S75W Application

**Proposed Modifications to Internal Fitout
Global Switch Data Centre (Stage 1)
273 Pyrmont Street, Ultimo**

**GLOBAL
SWITCH**

5 February 2015

Figure 2 Approved (top) and proposed Ground Floor alterations to internal partitioning to create single storage area, rather than 4 separate rooms (Source: dem)

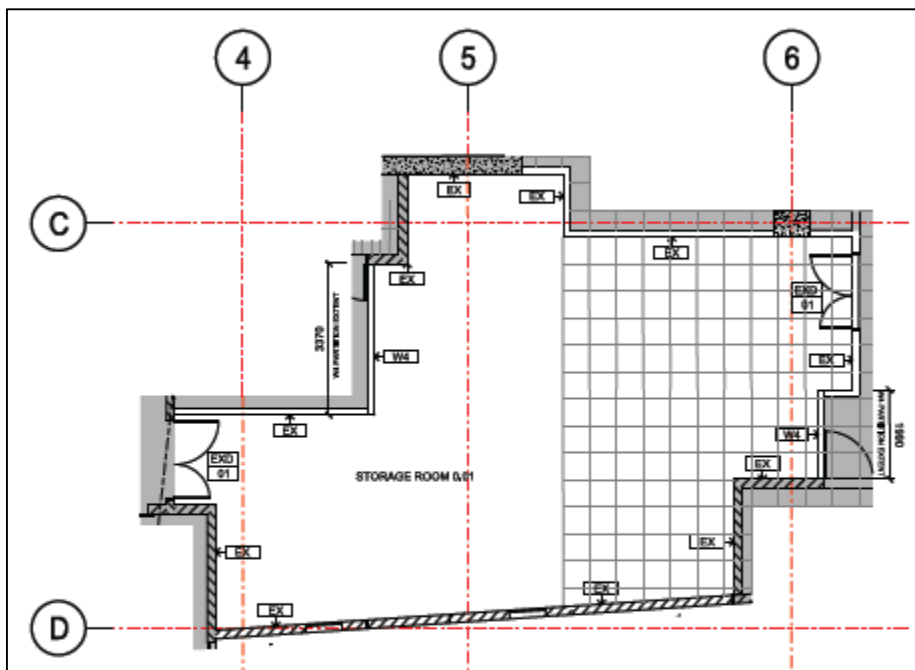
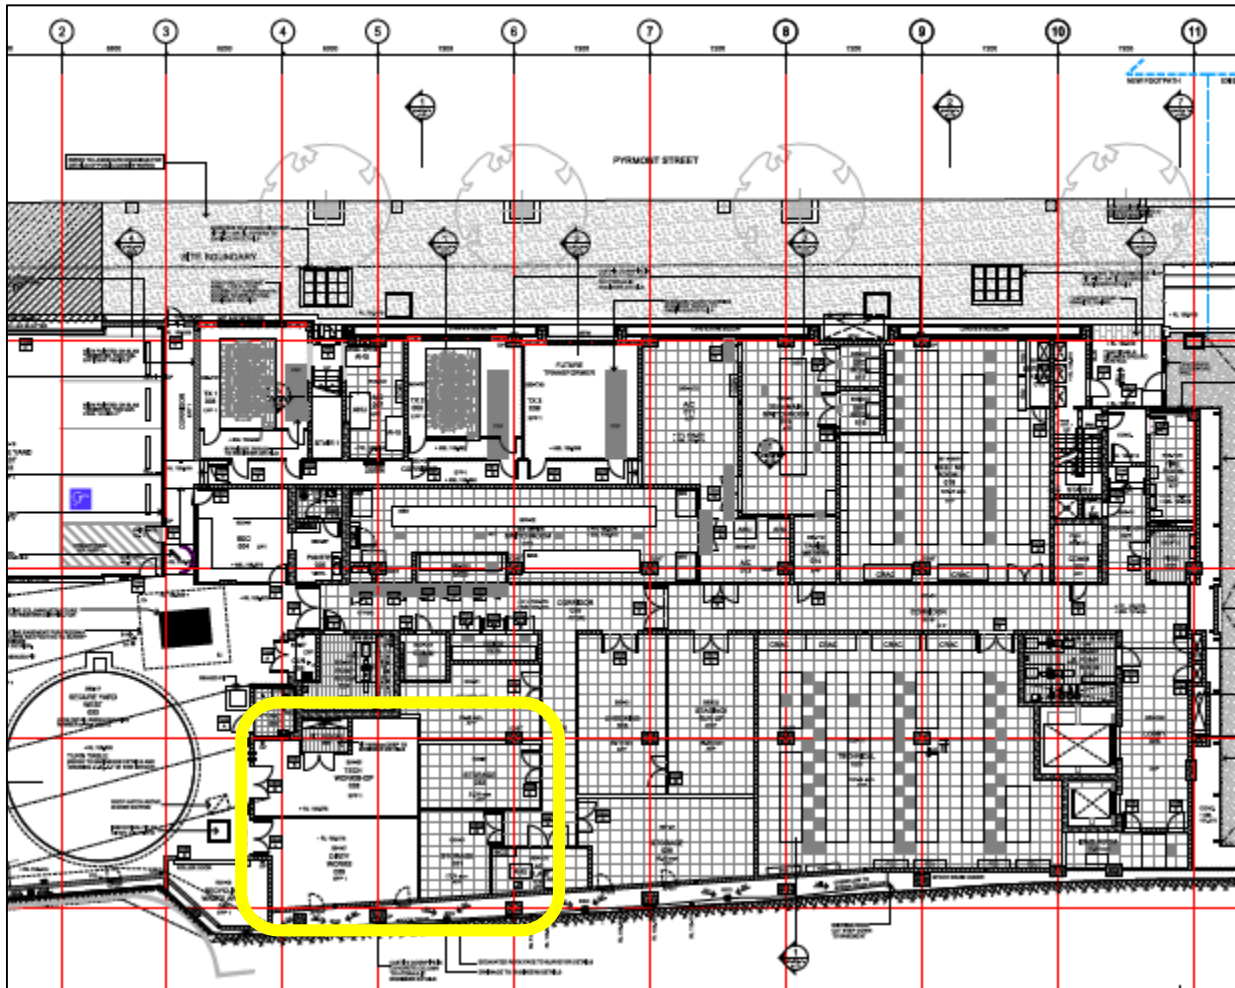
- internal partitioning in the north western corner of the Ground Floor to create a single storage room of 100m², rather than a series of smaller rooms (with the same floor area) as approved;
- introduction of additional internal partitioning in the south western corner of the Level 2 floor plate to create a series of work stations, a manager's office, meeting room, tea room and storage.

Figure 3 Approved (top) and proposed Level 2 floor plan (Source: dem)

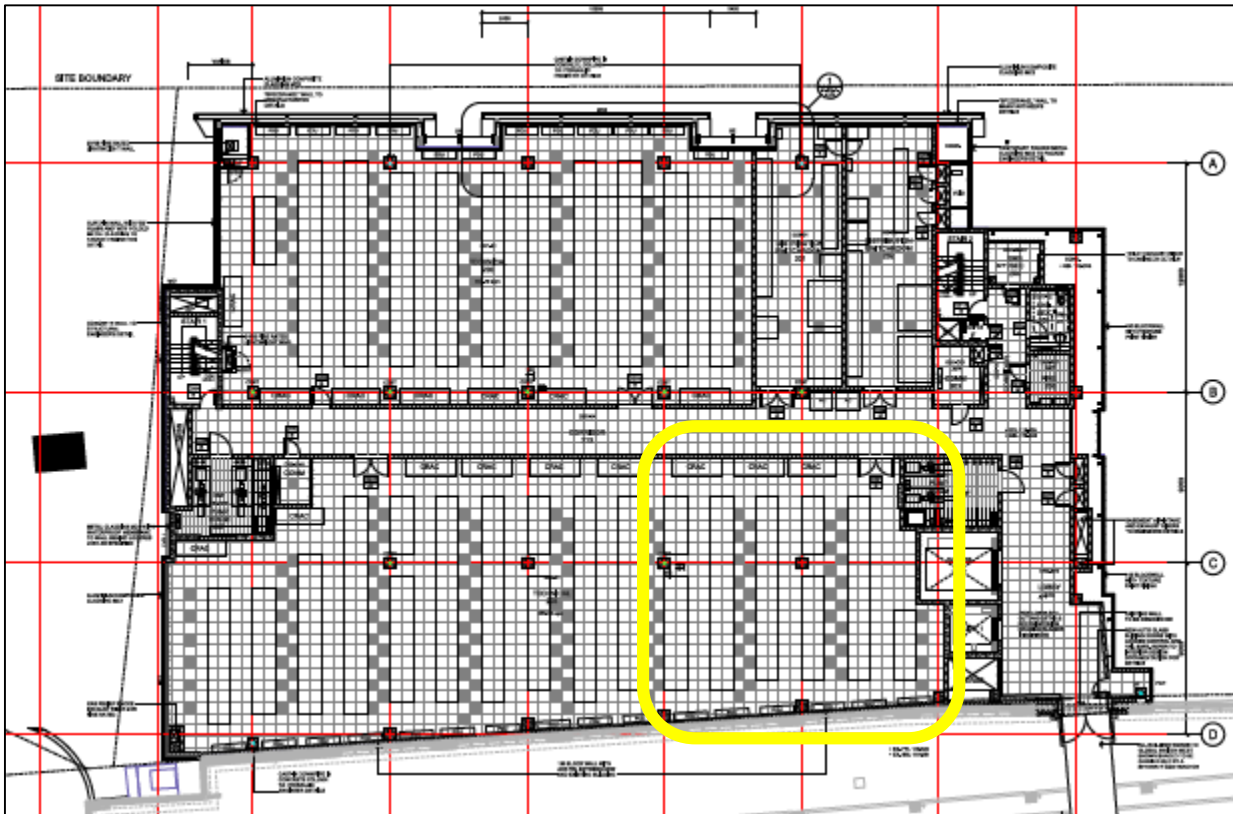
Accordingly, Global Switch has prepared this application which seeks approval for minor modifications to the layout of Level 2 in Stage 1 of the approved Data Centre which includes internal partitioning to create a series of work stations, a manager's office, meeting room, tea room and storage in the south western corner of the Level 2 floor plate. The tenant also requires a rationalisation of the storage area on the Ground Floor which effectively seeks to remove partition walls and consolidate four separate rooms into a single space.
